To: Prospective Bidders

From:
WBRC ARCHITECTS ENGINEERS
44 Central Street
Bangor, ME 04401-5116
(207) 947-4511
www.wbrcae.com

This Addendum forms a part of the Contract Documents and modifies the original Bidding Documents dated January 11, 2019, as noted below. Acknowledge receipt of the Addendum in the space provided on the Bid Form. Failure to do so may subject the Bidder to disqualification.

- Clarifications
- Specification Changes
- Reference Drawings: Extracted Structural Drawings from Original Christie Gym 1969 (2 sheets)

FOUNDATION PLAN AND DETAILS

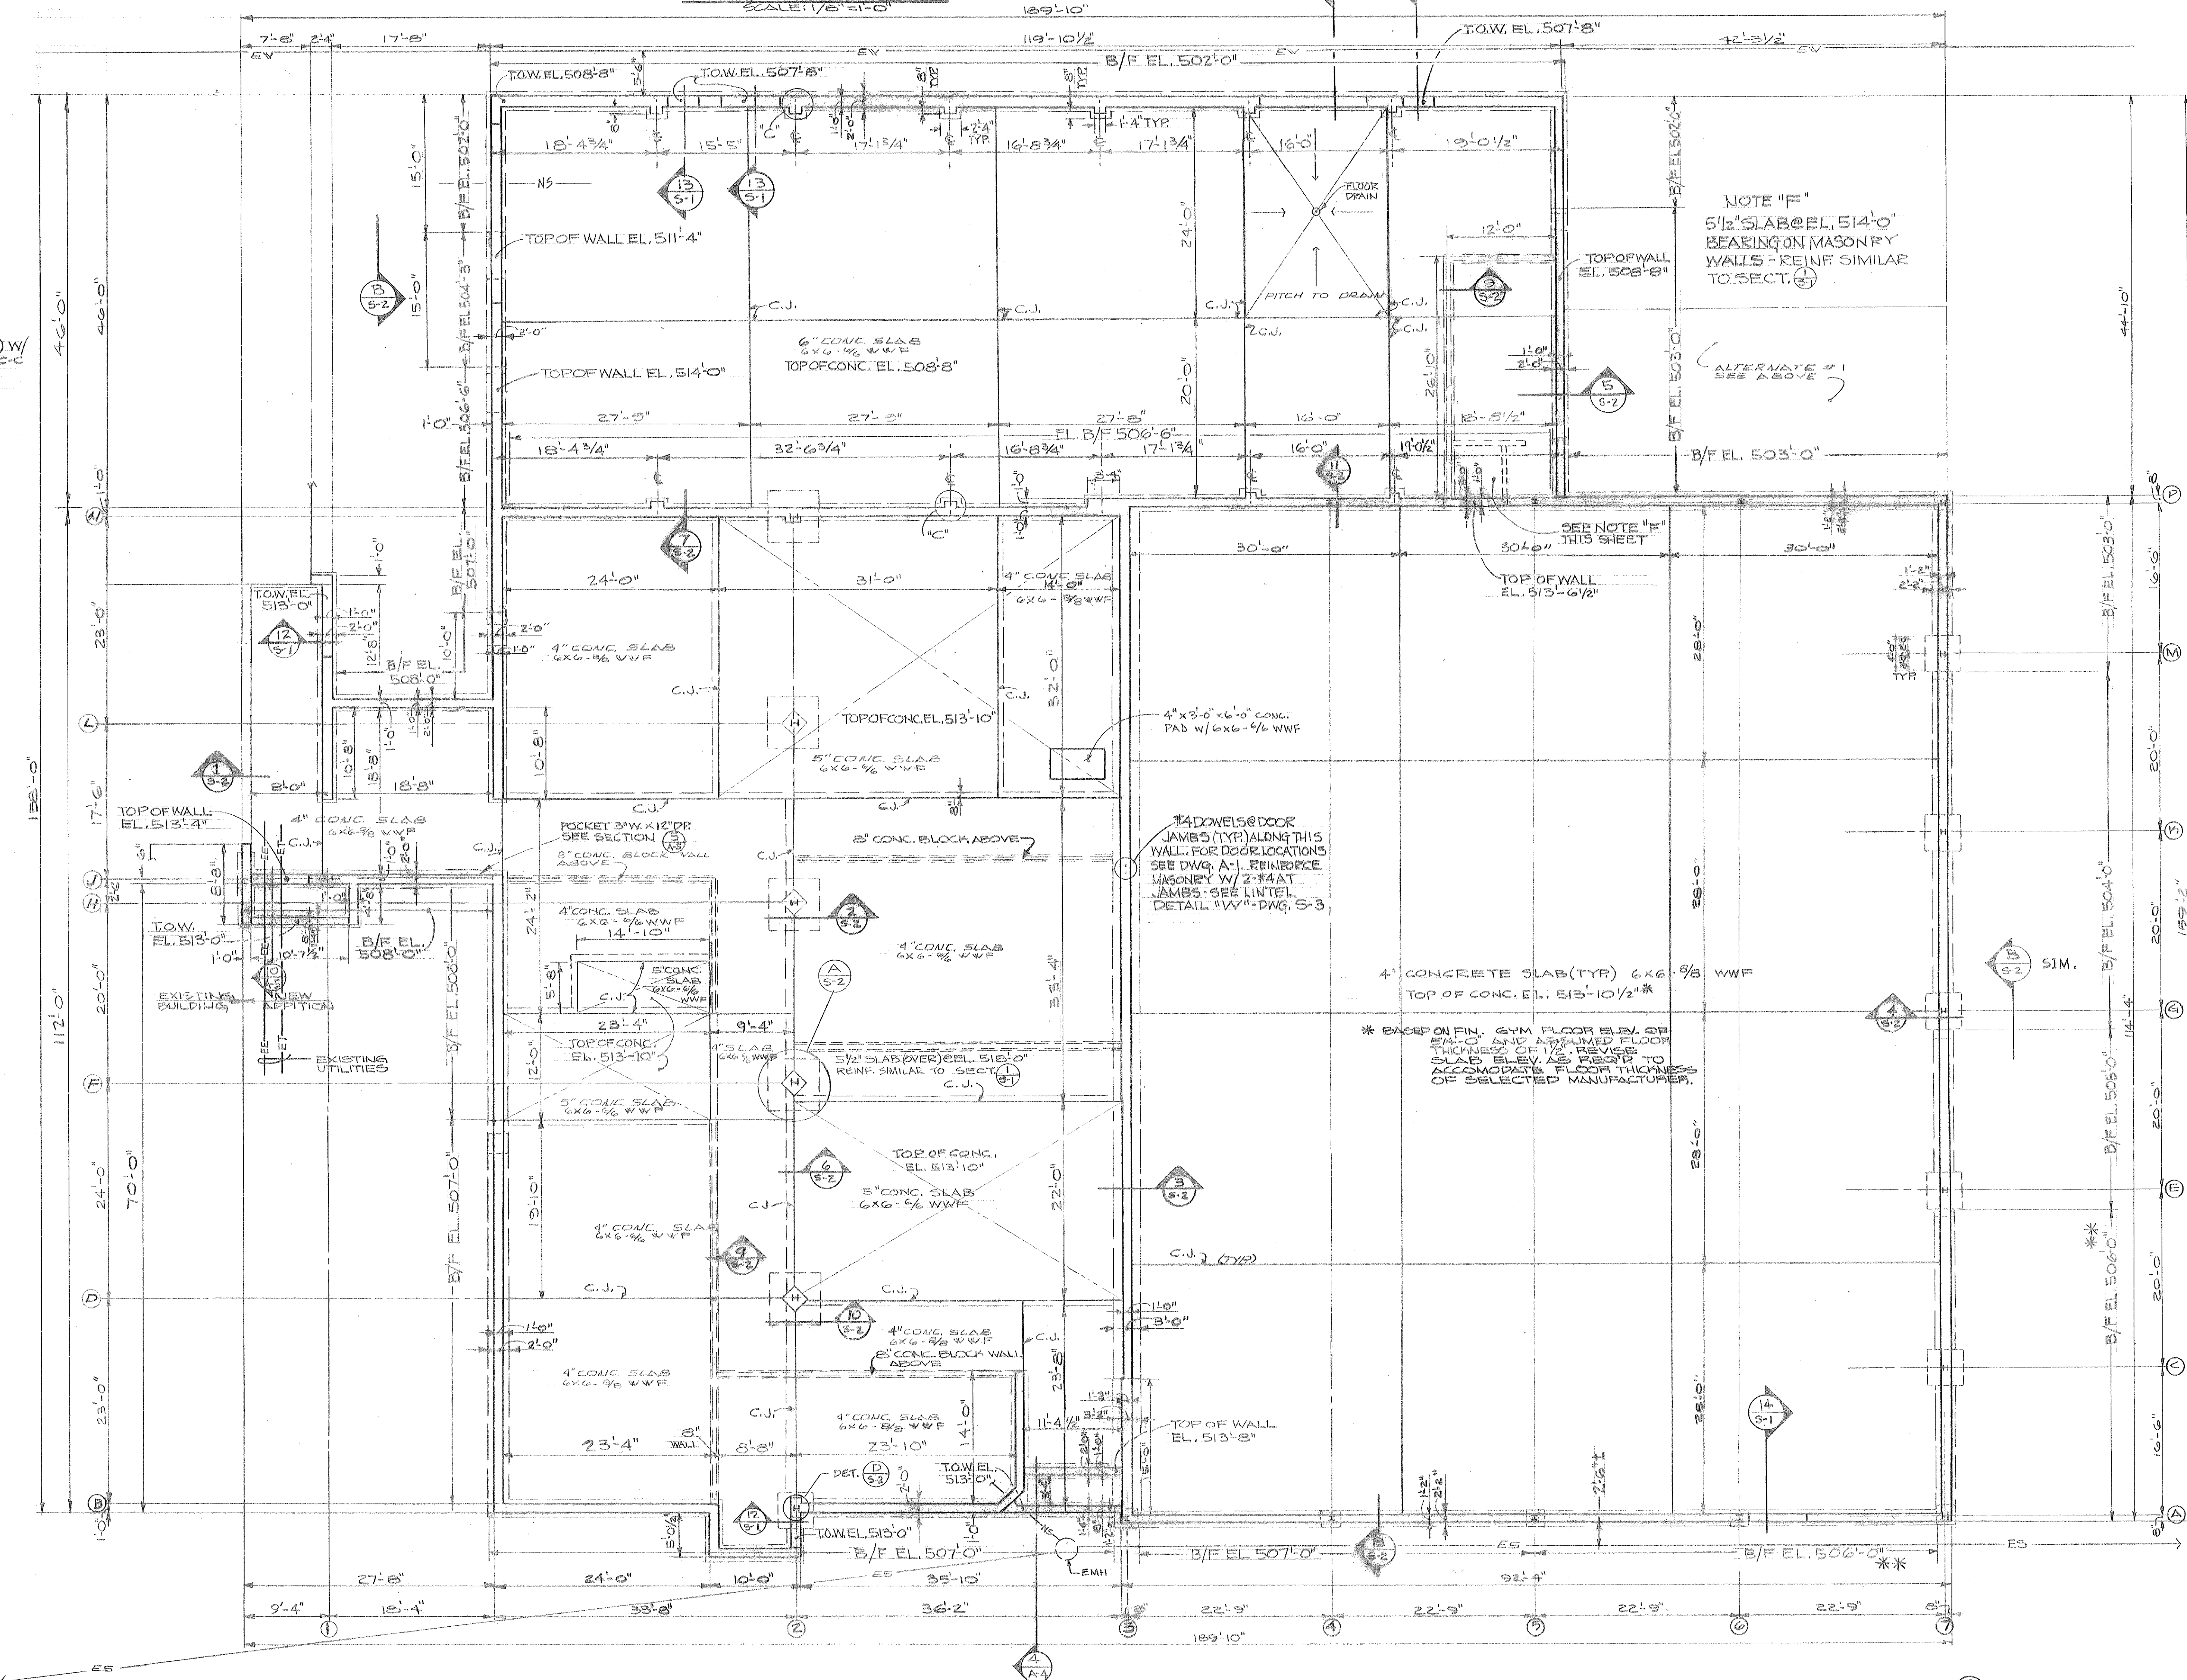
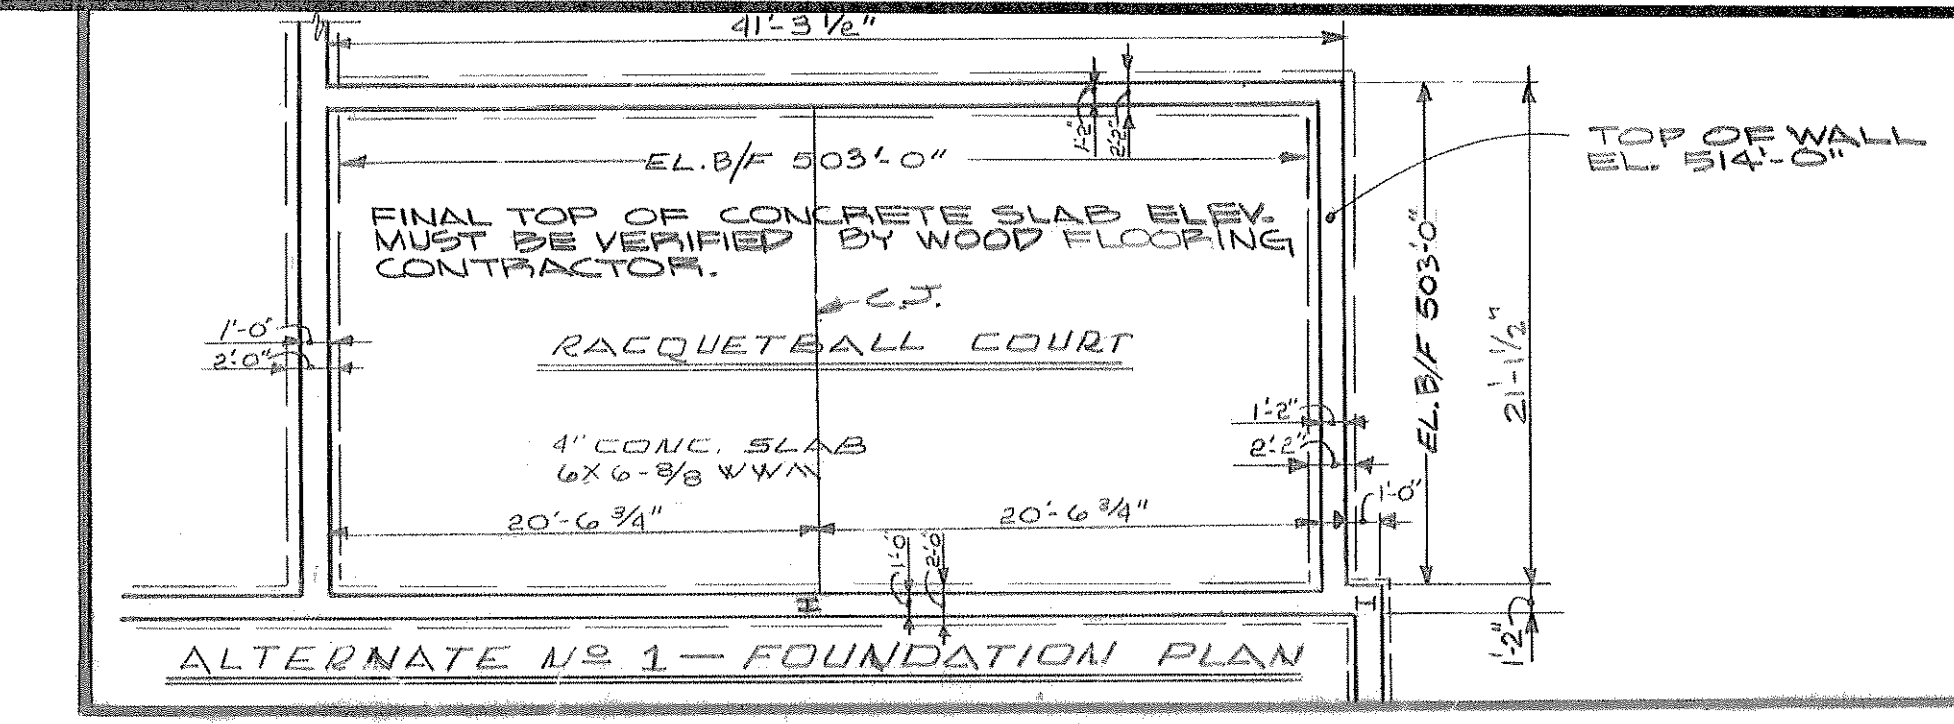
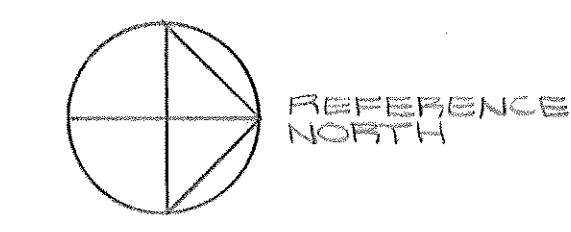
1. Question: Do you have information on the thickness of the existing slab? Is there polystyrene beneath?
Answer: Refer to attached structural drawings for the original Christie Gym (for information purposed only). These include foundation plan and foundation details.
